No. 15051-0235

PROJECT: 15051-Webster University Interdisciplinary Science Building

RE: Misc Steel Shop Drawings

△	
△ 9-19-16: FOR APPROVAL	
ATLAS IRON WORKS EST. 1922	
Project:	WEBSTER UNIVERSITY
Customer:	PARIC
Owner:	WEBSTER UNIVERSITY
Location:	WEBSTER GROVES, MD.
Dwn:	KRT
Date:	9-14-16
Ckd:	BD
Date:	9-19-16
Job No.	A16013M
DWG#:	E1

Project: WEBSTER UNIVERSITY
Customer: PARIC
Owner: WEBSTER UNIVERSITY
Location: WEBSTER GROVES, MO.
Dwn: KRT Date: 8-30-16 Ckd: BD Date: 9-19-16
Job No. A16013M DWG#: 1

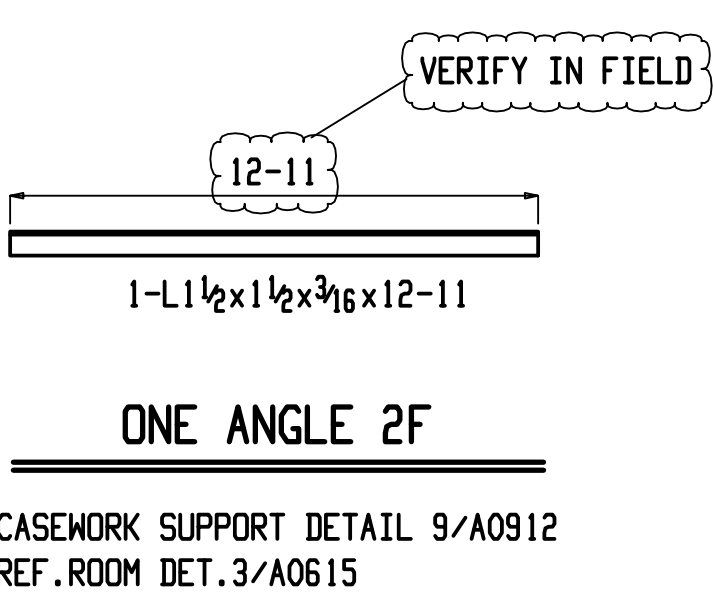
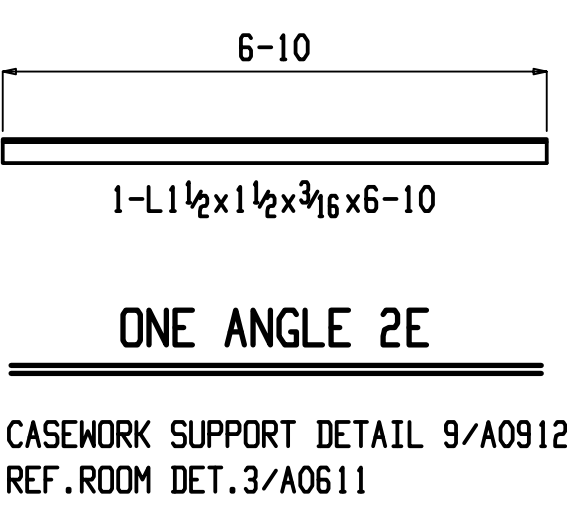
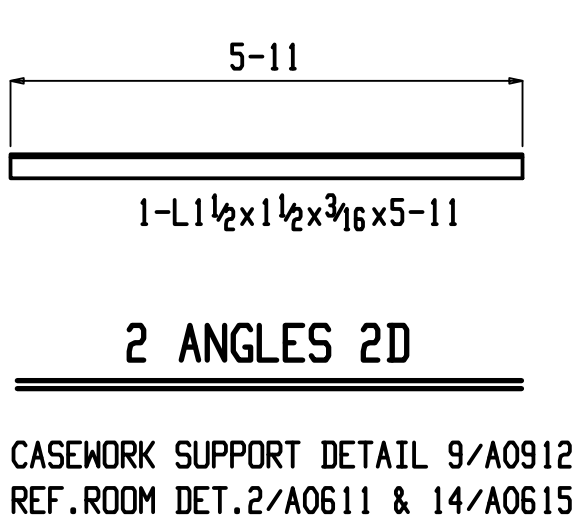
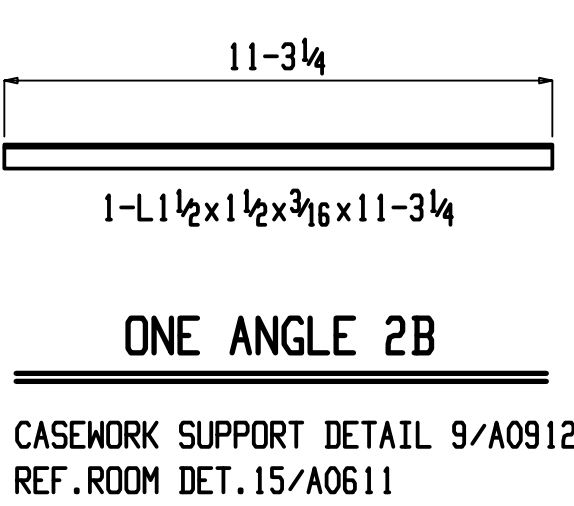
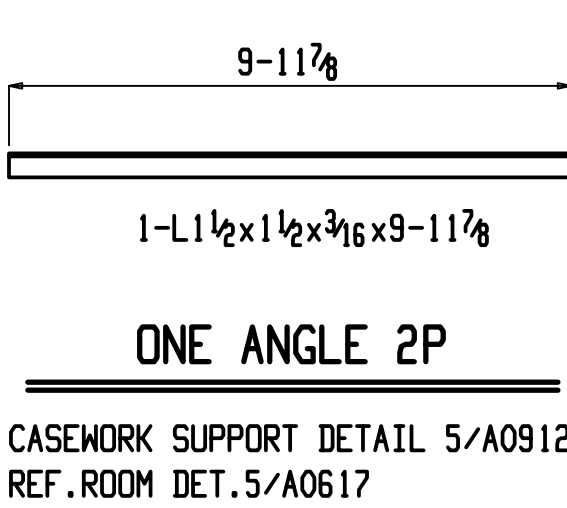
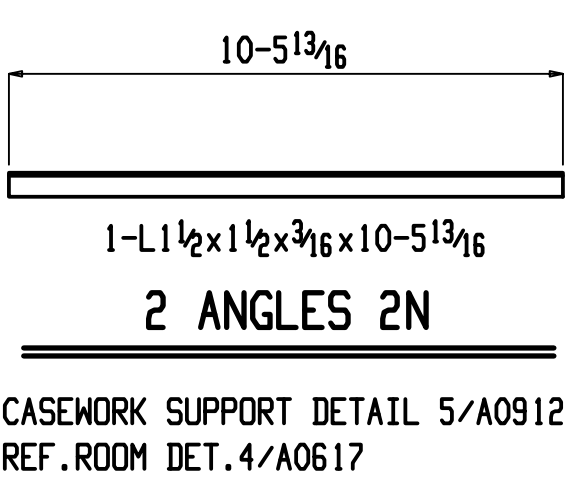
APPROVER: VERIFY ANGLE SIZE,
PROVIDE HOLE SIZE AND SPACING
IF REQ'D. TYPICAL AT ALL ANGLES
THIS SHEET.
VERIFY ANGLES ARE CONTINUOUS AND
HEBGO BRACKETS TO BE NOTCHED AT
CONTINUOUS ANGLE.

GC TO COORDINATE .

PLEASE VERIFY L LENGTHS ARE
SUCH THAT THEY CAN GET INTO THE
BUILDING

STEEL ANGLES TO BE CONTINUOUS
BETWEEN COUNTERTOP SUPPORTS.

NOTCHING OF HEBGO BRACKETS IS
NOT ACCEPTABLE.

Project: WEBSTER UNIVERSITY
Customer: PARIC
Owner: WEBSTER UNIVERSITY
Location: WEBSTER GROVES, MD.
Dwn: KRT Date: 09-12-16 Ckd: BD Date: 9-19-16
Job No. A16013M DWG#: 4

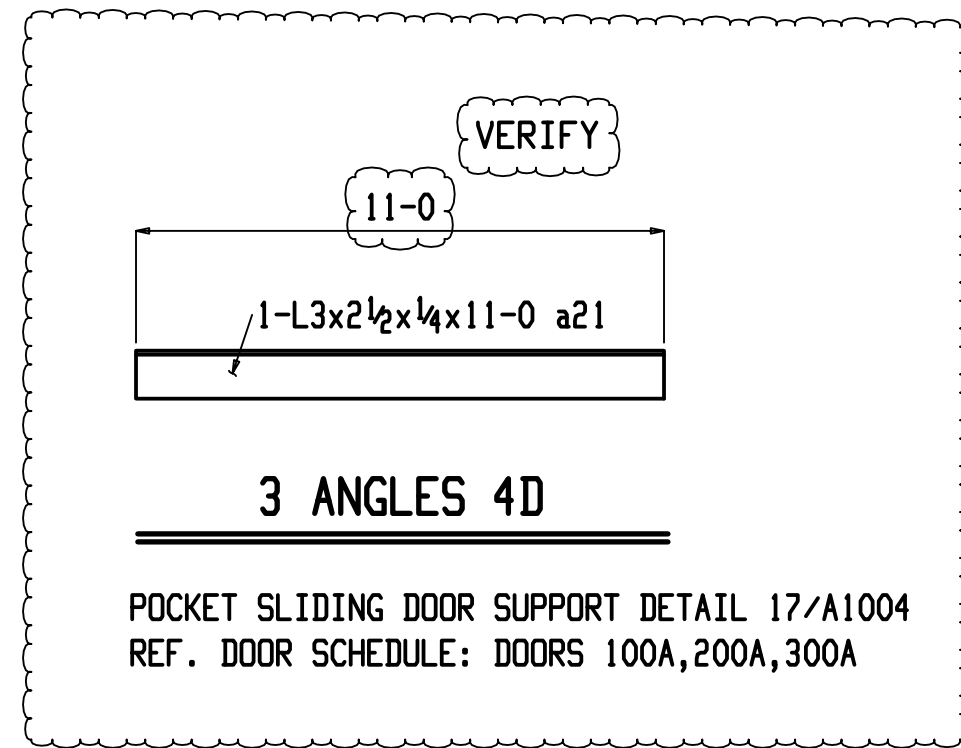
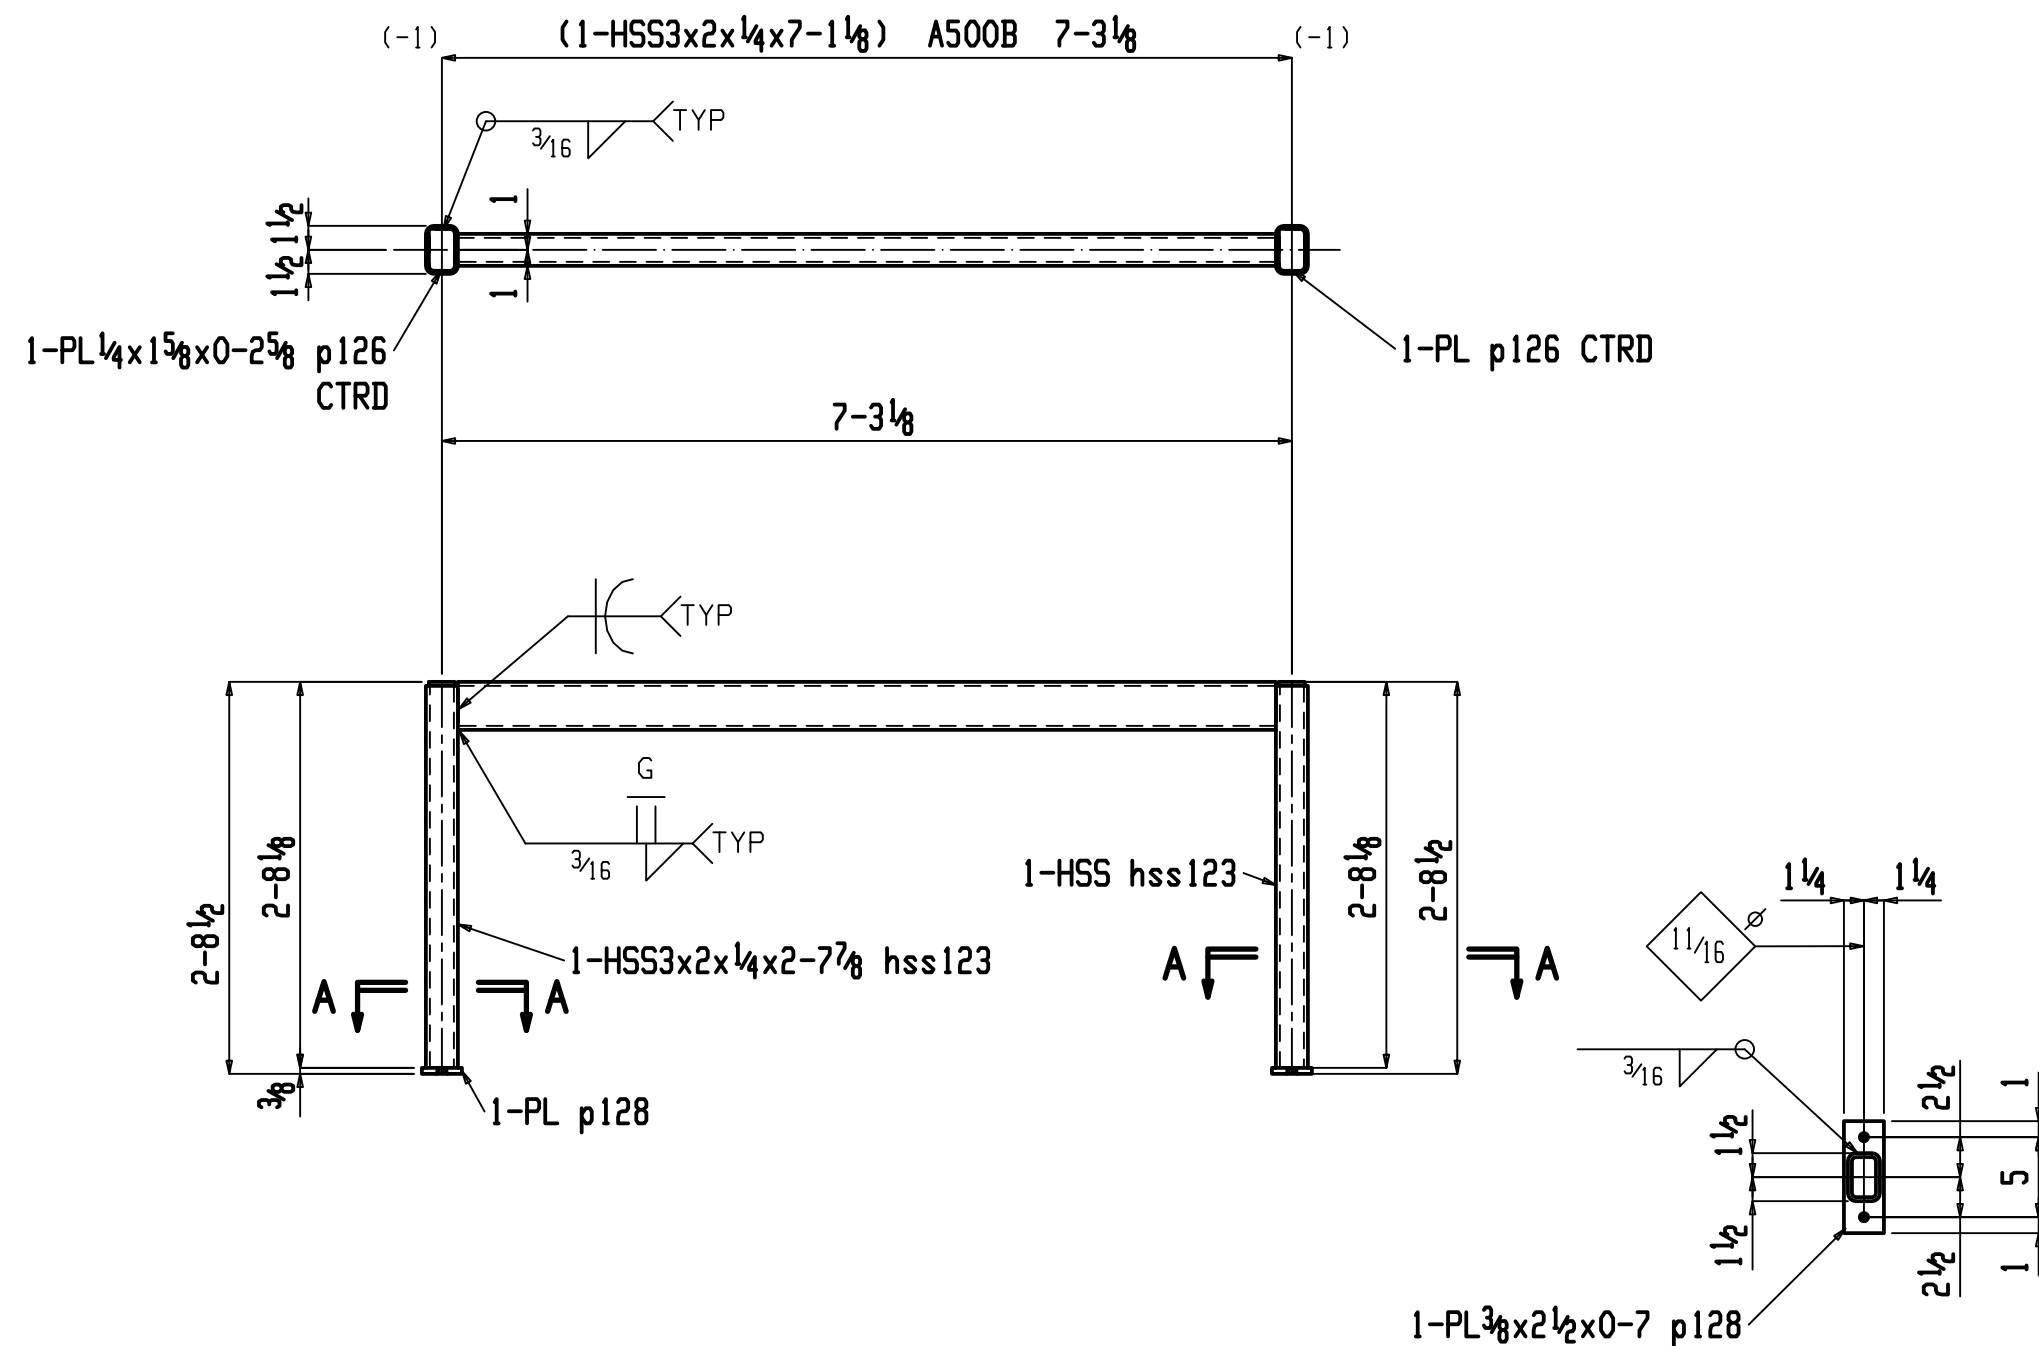
HOLD

GENERAL
CONTRACTOR TO
COORDINATE

VERIFY

SURFACE PREP AS
REQUIRED FOR PAINT

PAINTED

ONE HANDRAIL 5A
GALVANIZE

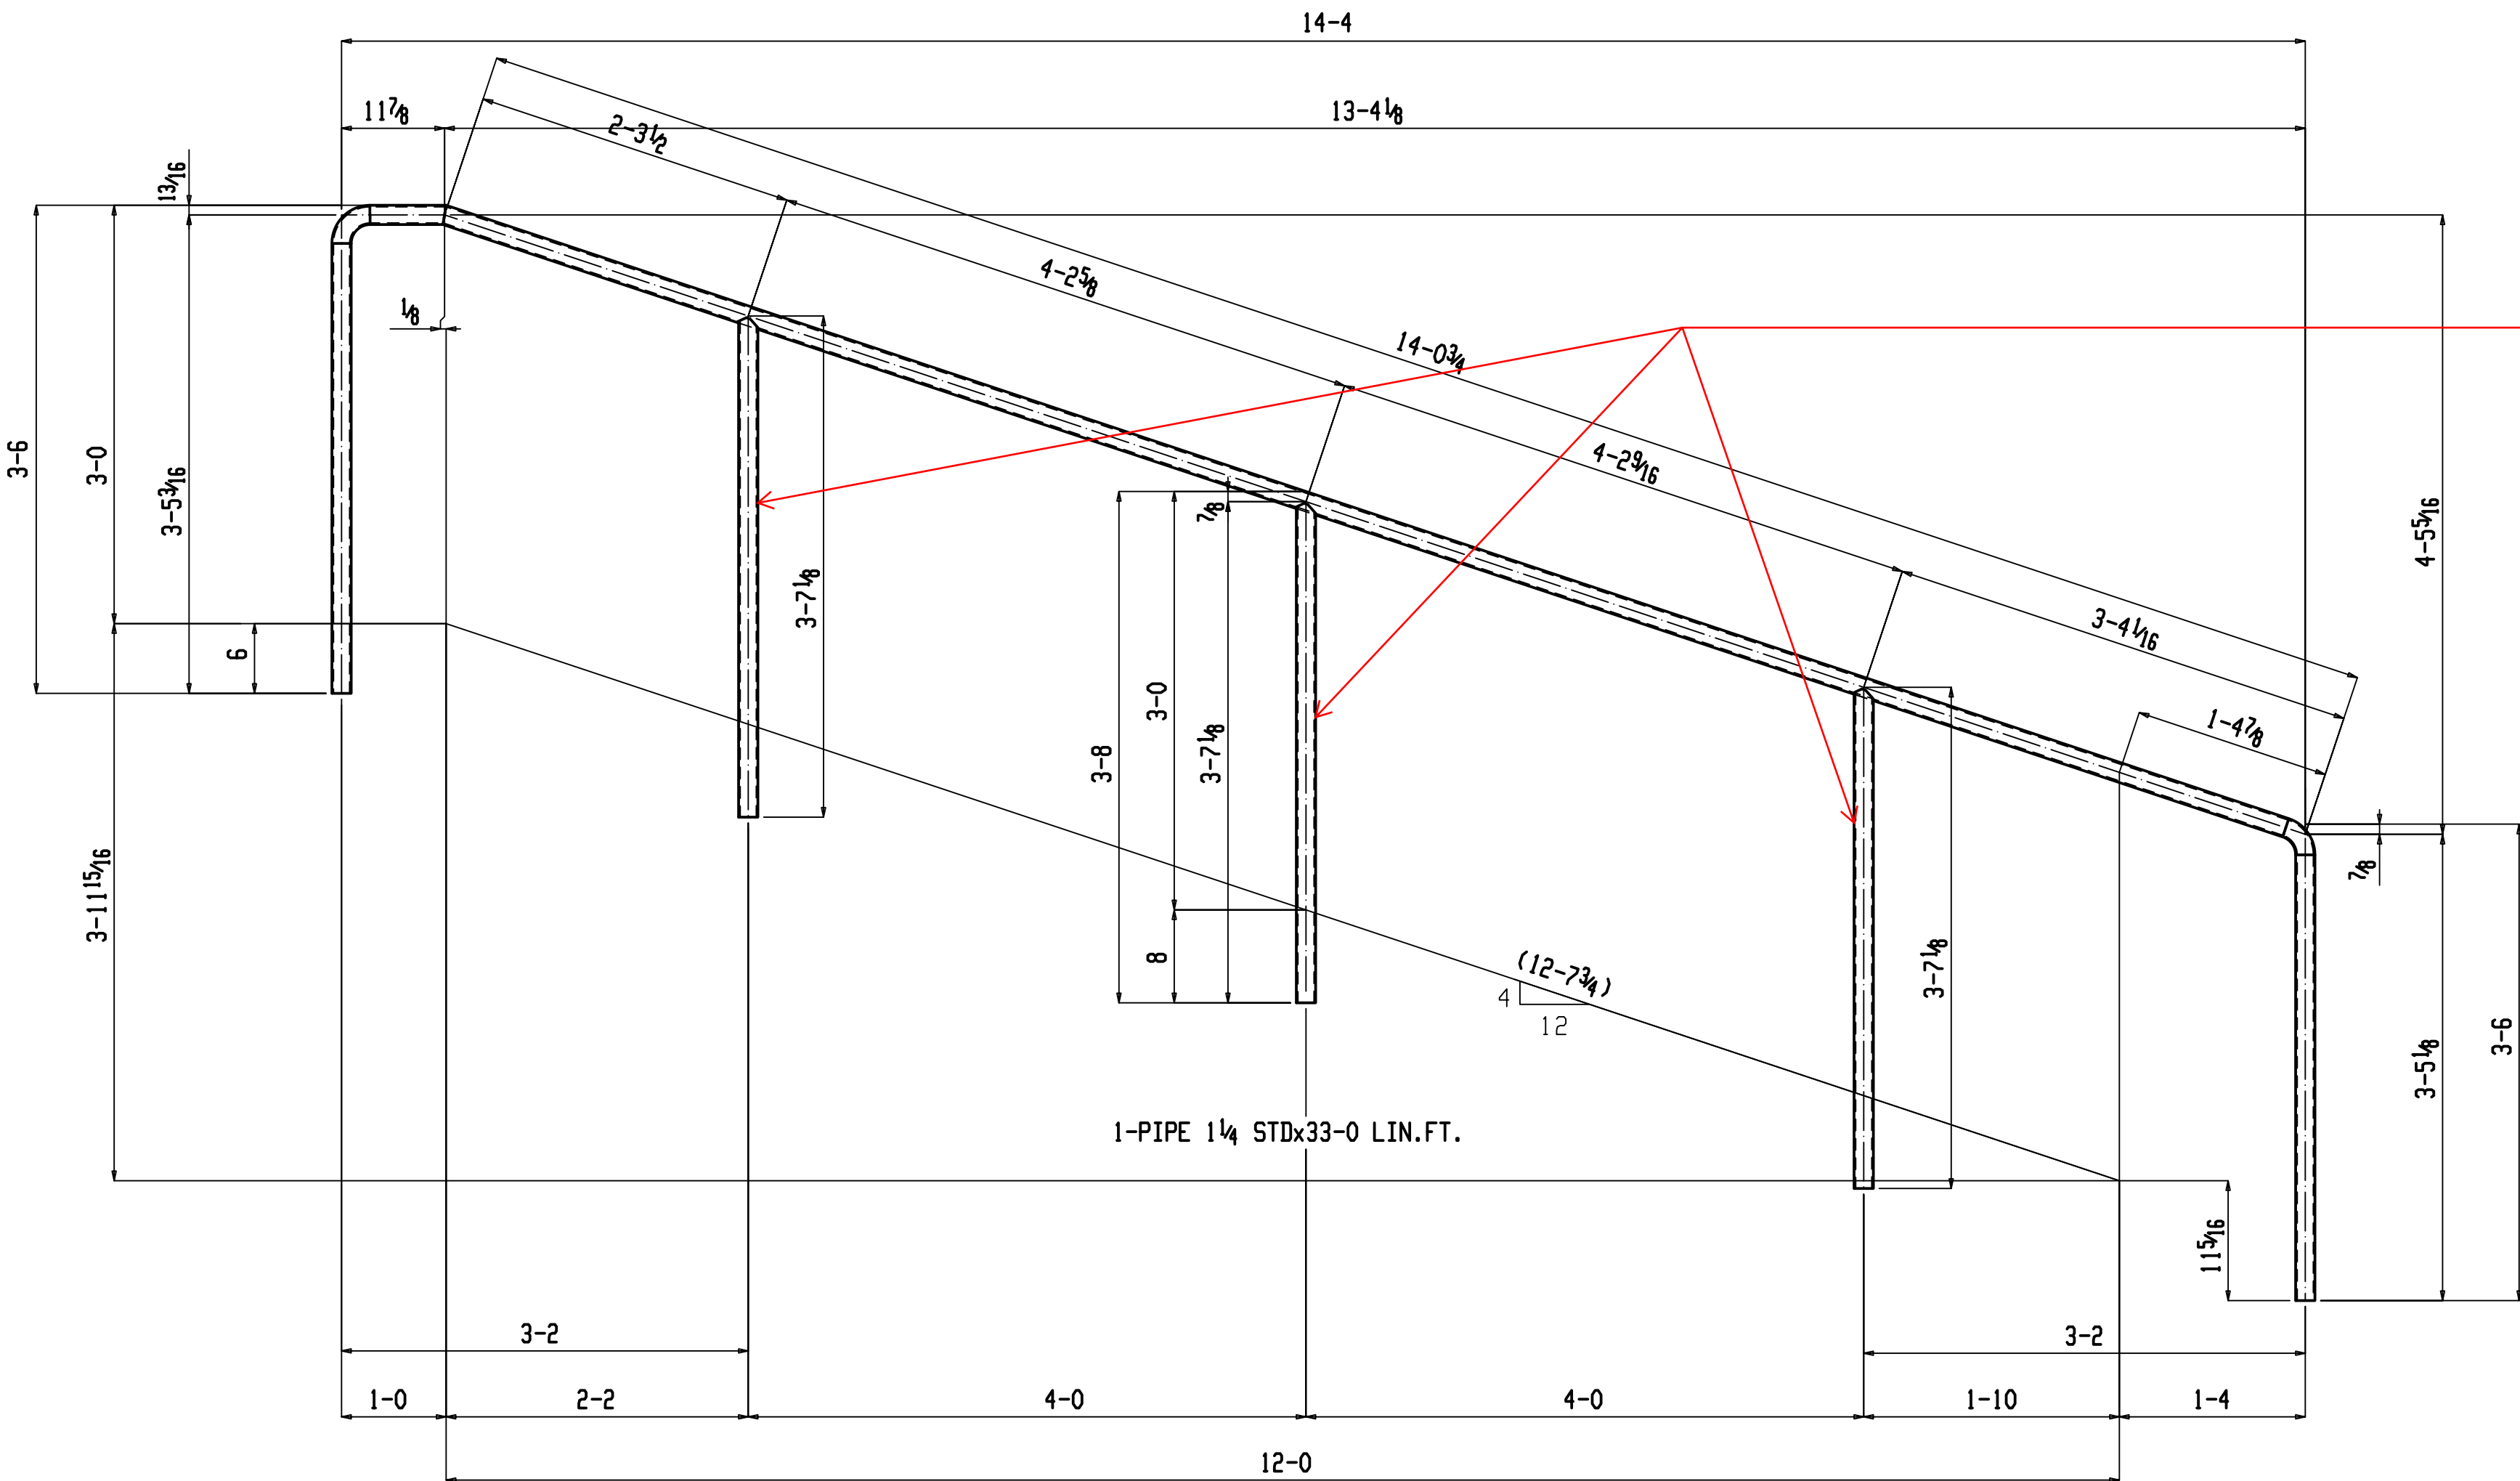
VERIFY

PER SPECIFICATIONS
